Access Compliance Report

Public Rights-of-Way

Intersection ID: 31171	Main Street: POINTER_RD	Cross Street: BROWNE_RD	Location: SE
ADA ID: D90BE2AF02C0	Ramp Type: Para	Initial Pass/Fail: Fail	Overall Compliance: No
			Severity Score: 26.25

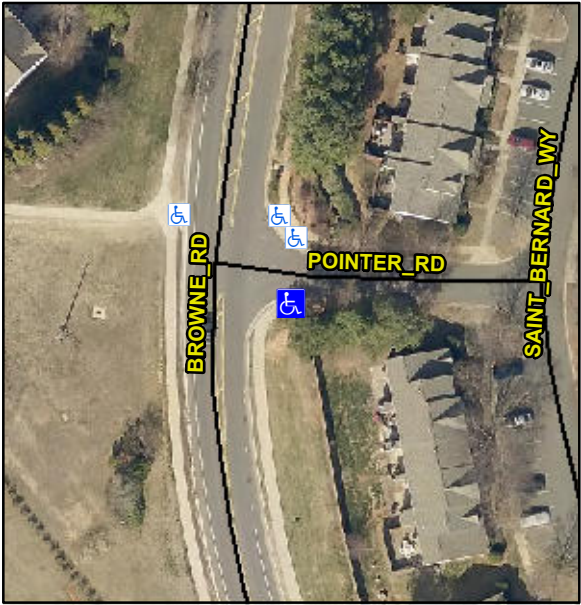
Codes/Mitigation Info/Possible Solution			Field Measurements/Component Compliance		
 <p>Street 1 Name POINTER RD</p> <p>Stop Condition-Street 1 StopSign</p> <p>Street 2 Name N/A</p> <p>Stop Condition-Street 2 N/A</p>	Possible Solutions:		Compliance	Description	Data
	Remove & Replace Entire Ramp.		N/A	Ramp Length LT (in)	68.0
			Yes	Ramp Width LT (in)	71.0
			Yes	Ramp Slope LT (%)	2.9
			No	Ramp XSlope LT (%)	2.3
			N/A	Landing Length (in)	N/A
			N/A	Landing Width (in)	N/A
			N/A	Landing Slope (%)	N/A
			N/A	Landing X Slope (%)	N/A
			N/A	Landing Curb? (Y/N)	N/A
			N/A	Shared Landing?	N/A
			N/A	Gutter Ponding?	N/A
			N/A	Gutter Lip Ht (in)	N/A
			N/A	Painted X Walk1?	No
			N/A	X Walk 1 Direction	To N
			N/A	X Walk 1 Width (in)	N/A
				X Walk 1 Slope (%)	1.2
				X Walk 1 X Slope (%)	4.4
			N/A	Ramp inside XWalk1?	N/A
				Road Slope (%)	N/A
				Road X Slope (%)	N/A
			N/A	Any Obstructions?	N/A
				Obstruction Type

N/A		N/A
			Yes	Surface Condition? (G/P)	Good
			N/A	Curb Slope (%)	N/A
<p>Surveyor Notes:</p> <p>LT RP < 5%</p> <p>PROW/ADA:</p> <p>R304.5.3, R304.3.2</p> <p>Total Cost: \$ 1600.00</p>
